Re: Additional Data Required for Letter of Map Revision (LOMR)
Case No. 18-01-0144P
Town of Exeter, New Hampshire (Community No. 330130)
Great Dam Removal, Exeter River, FIRM Panels 33015C0382E, 0402E, 0403E, 0404E, 0406E, and 0408E

This letter addresses the issues listed in the letter from Benjamin Kaiser dated December 5, 2017 requesting additional data to complete your review for the LOMR request for the Great Dam Removal on the Exeter River in Exeter, NH (Case No. 18-01-0144P). Please find attached an electronic copy of the requested LOMR supporting data. David Cloutier of VHB spoke with Ellie Pitney by phone on Friday, December 15, 2017 to review the comments and confirm that the following revisions to the submittal are consistent with FEMA requirements. We have provided a point-by-point response to your comments below (responses in **bold type**):

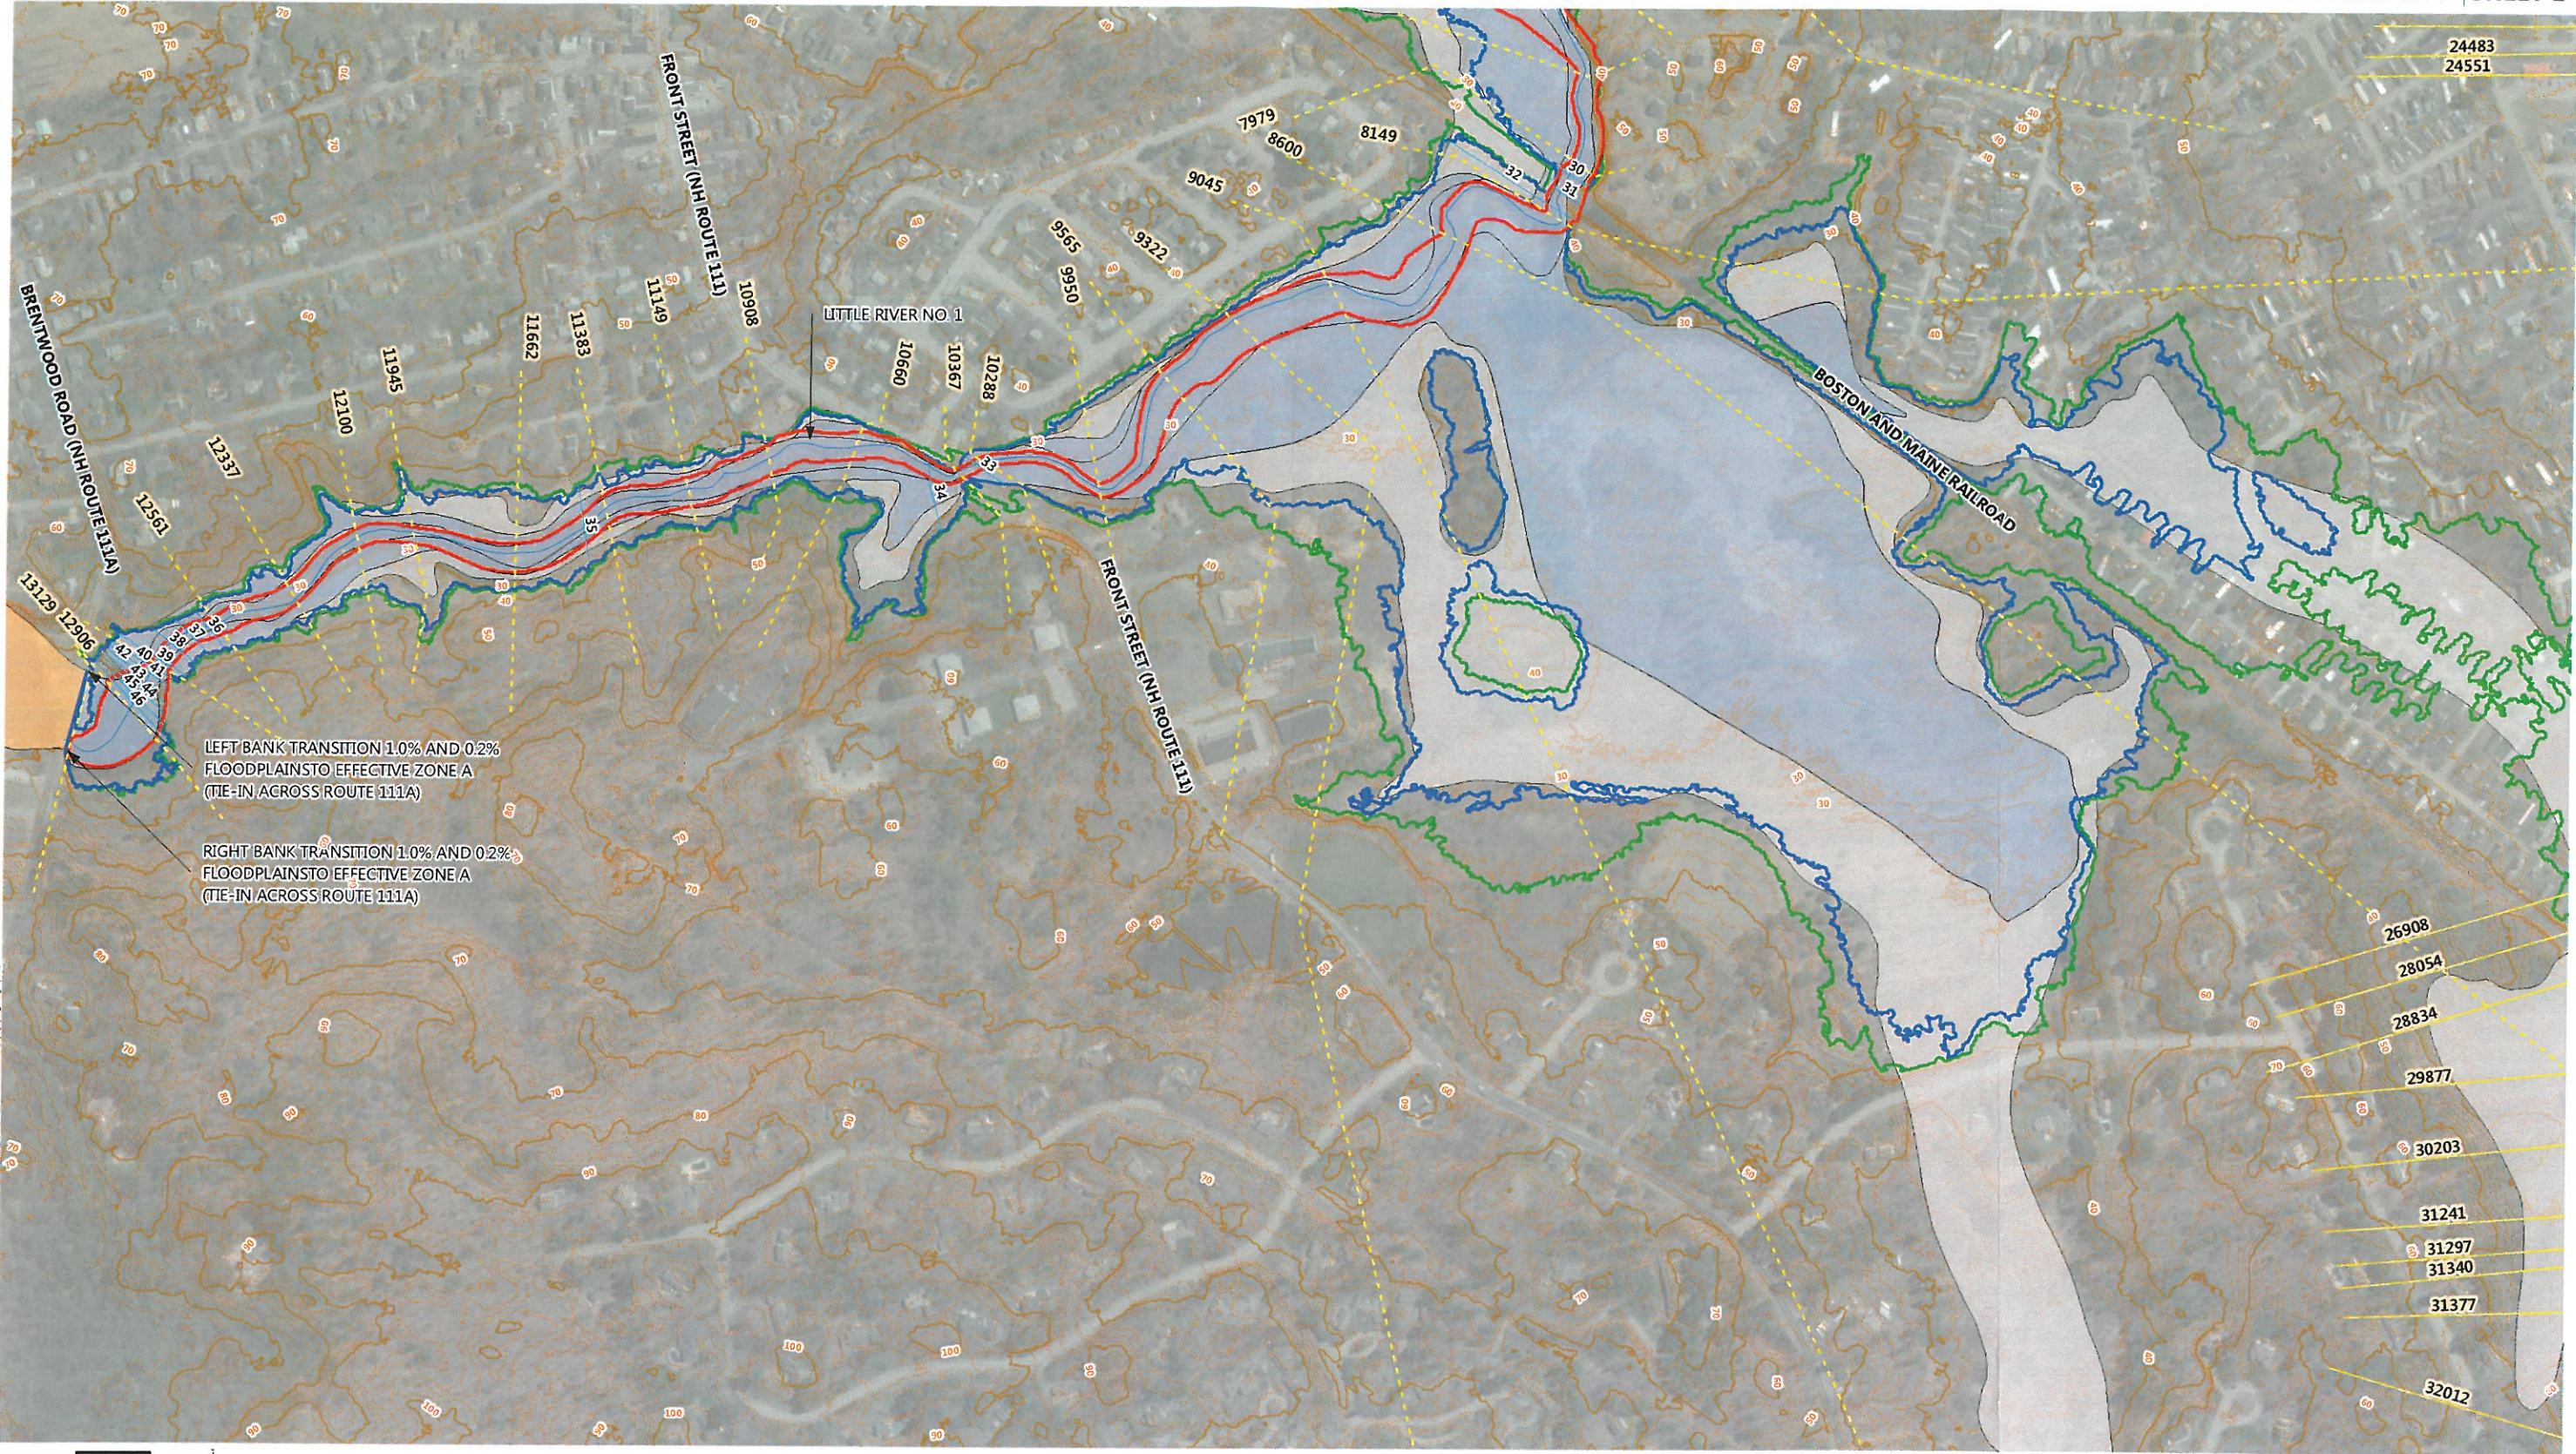
- c) Our review of the workmap and hydraulic model revealed that the upstream most Cross Section 12906 is set approximately 240 feet downstream of the effective limit of study. Please add another cross section right at the limit of study location so that entire revision area can be updated based on the updated Water Surface Elevation (WSEL).

- d) The topwidths of the base floodplain computed in the post-project conditions HEC-RAS hydraulic model at Cross Section 12907 do not match the approximate floodplain topwidths shown on the above-referenced topographic work map. As per the model, the topwidth is 324 feet, but it is approximately 297 feet in the work map. Please provide an explanation for the discrepancy, or submit a revised hydraulic analysis and/or work maps as appropriate.

VHB has added an additional Cross Section, 13129, at the upstream limit of study immediately downstream of the Brentwood Road (NH Route 111A) crossing. HEC-RAS model has been revised to add this new cross-section and the 1%- and 0.2%- floodplains have been re-delineated upstream of Cross Section 12907. The floodway encroachment table and Topographic Work Map have been revised to incorporate these changes.

VHB re-delineated the base floodplain from Cross Section 12907 to the upstream limit of study to address comment c) above. After re-delineating the floodplain, VHB reviewed the mapped floodplain width at Cross Section 12907 to verify that it was consistent with the HEC-RAS model. The HEC-RAS model top width is 324.4 feet, but this includes a small isolated area between station 40 and 50, to the left of the limit of effective flow – this area is a local low point with no hydraulic connection to the floodplain. The effective flow topwidth (removing this isolated area) is 317.65, consistent with the mapped floodplain width in the Topographic Work Map.

LEFT BANK TRANSITION 1.0% AND 0.2% FLOODPLAIN TO EFFECTIVE ZONE A (TIE-IN ACROSS ROUTE 111A)

RIGHT BANK TRANSITION 1.0% AND 0.2% FLOODPLAIN TO EFFECTIVE ZONE A (TIE-IN ACROSS ROUTE 111A)
